**NZ 29/16 NEW ZEALAND – North Island – East Coast – Hen and Chicken Islands – Marotere Islands
– Light.**

Former notice – NZ 232(P)/15 is cancelled.

| NZ 128/15 | NZ 29/16 | NZ 52 |

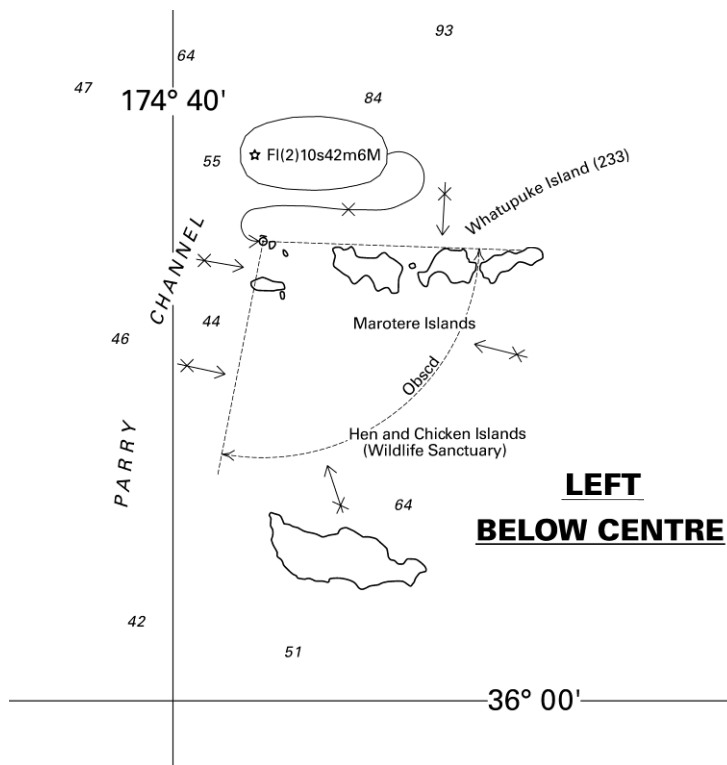
Chart NZ 52 [128/15]

Insert ★ Fl(2)10s42m6M (a) 35° 52'.96S., 174° 41'.70E.
obscured sector at light: 272°-011° (99°) (a) above

| NZ 254/15 | NZ 29/16 | NZ 53 |

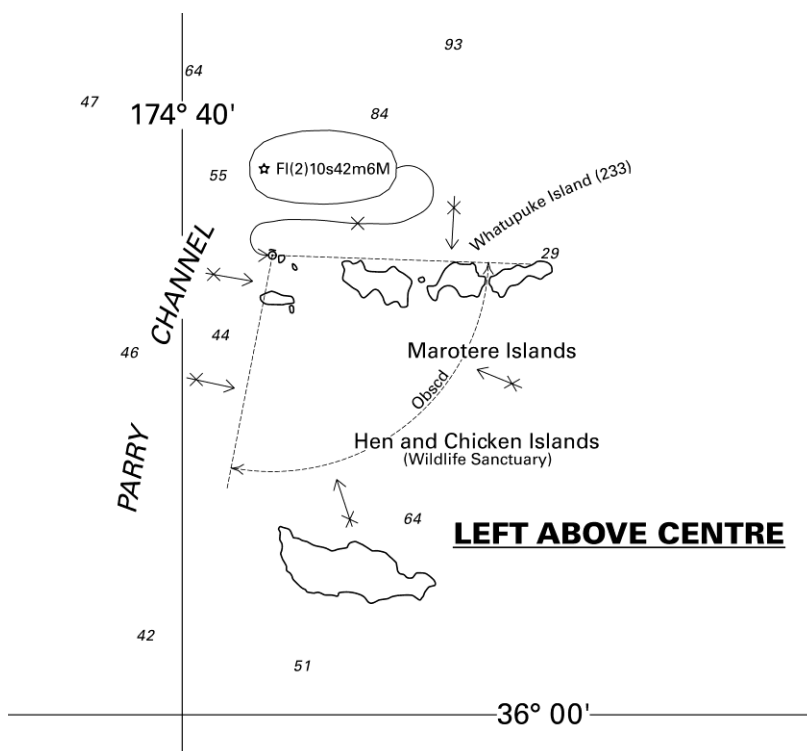
Chart NZ 53 [254/15]

Insert ★ Fl(2)10s42m6M (a) 35° 52'.96S., 174° 41'.70E.
obscured sector at light: 272°-011° (99°) (a) above

| NZ 28/16 | NZ 29/16 | NZ 521 | |

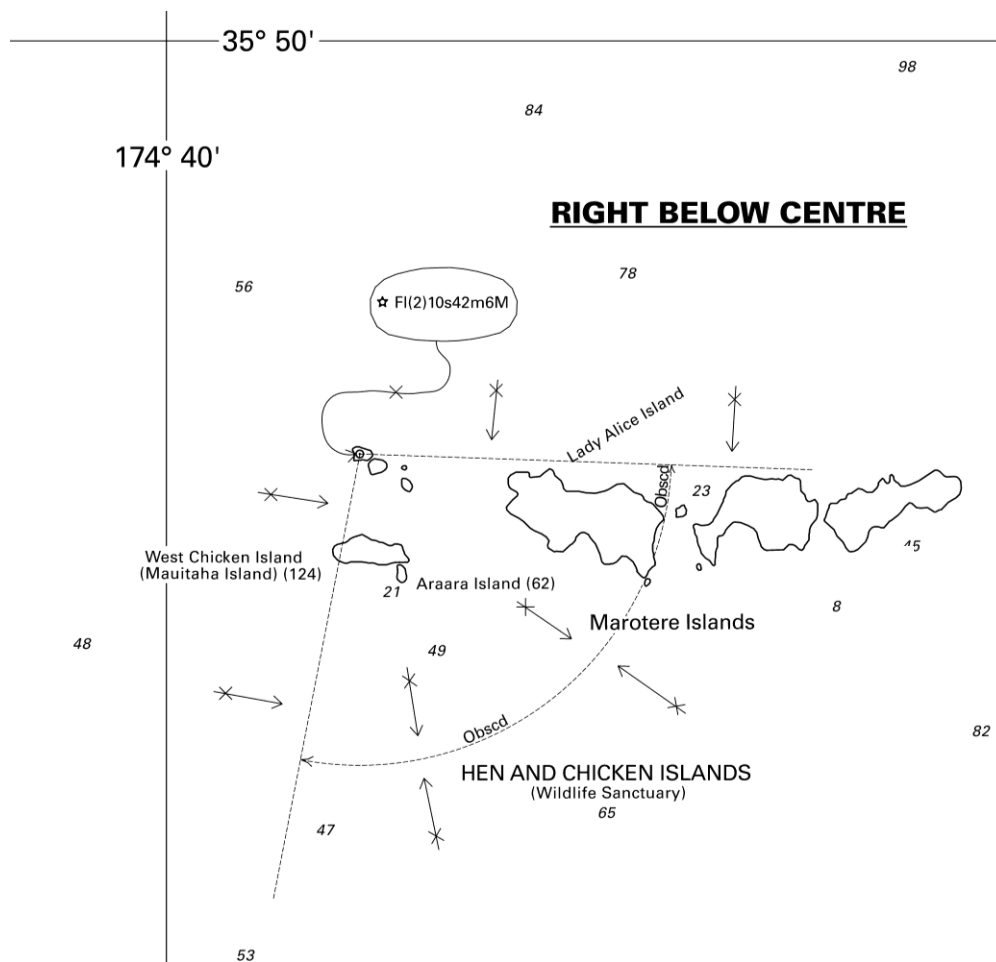
Chart NZ 521 [28/16]

Insert ★ Fl(2)10s42m6M (a) 35° 52'.96S., 174° 41'.70E.
obscured sector at light: 272°-011° (99°) (a) above

| NZ 241/15 | NZ 29/16 | NZ 522 | |

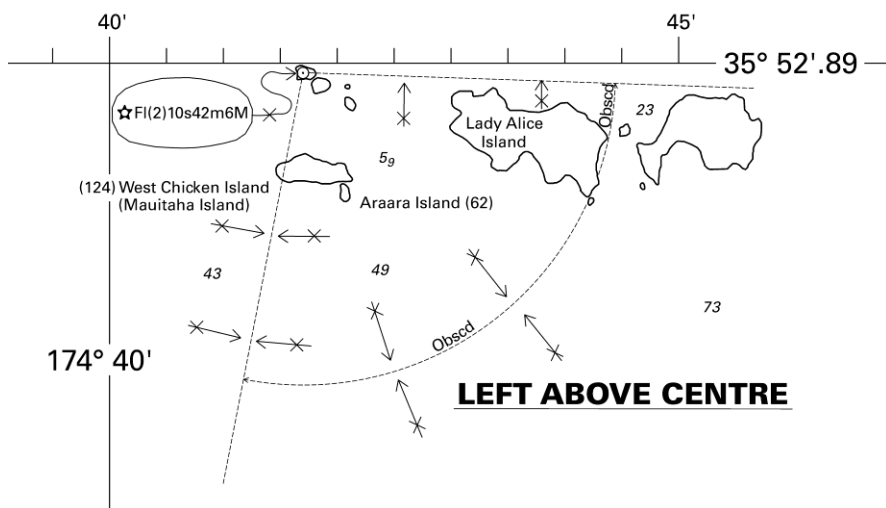
Chart NZ 522 [241/15]

Insert ★ Fl(2)10s42m6M (a) 35° 52'.96S., 174° 41'.70E.
obscured sector at light: 272°-011° (99°) (a) above

| NZ 32/14 | NZ 29/16 | NZ 5219 | |

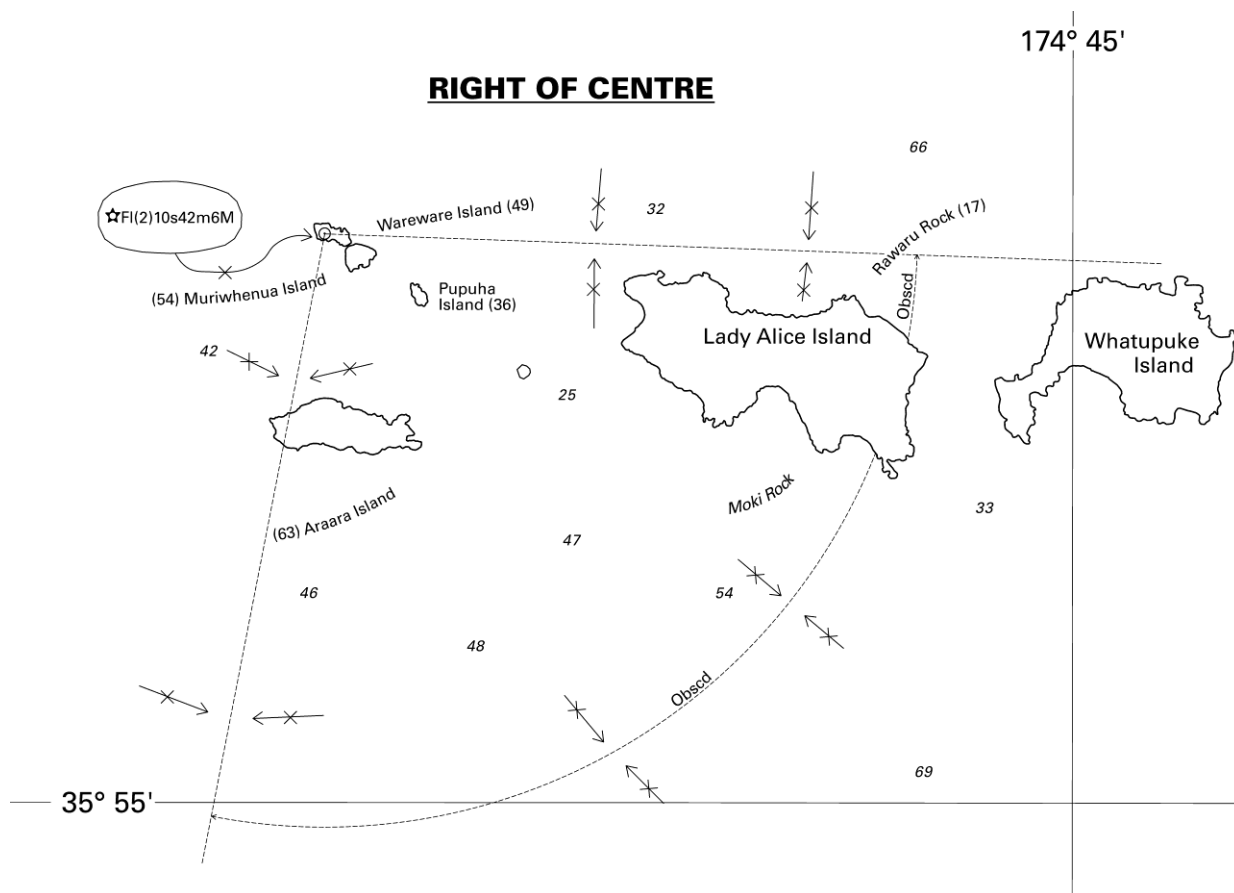
Chart NZ 5219 [32/14]

Insert ★ Fl(2)10s42m6M (a) 35° 52'.96S., 174° 41'.70E.
obscured sector at light: 272°-011° (99°) (a) above
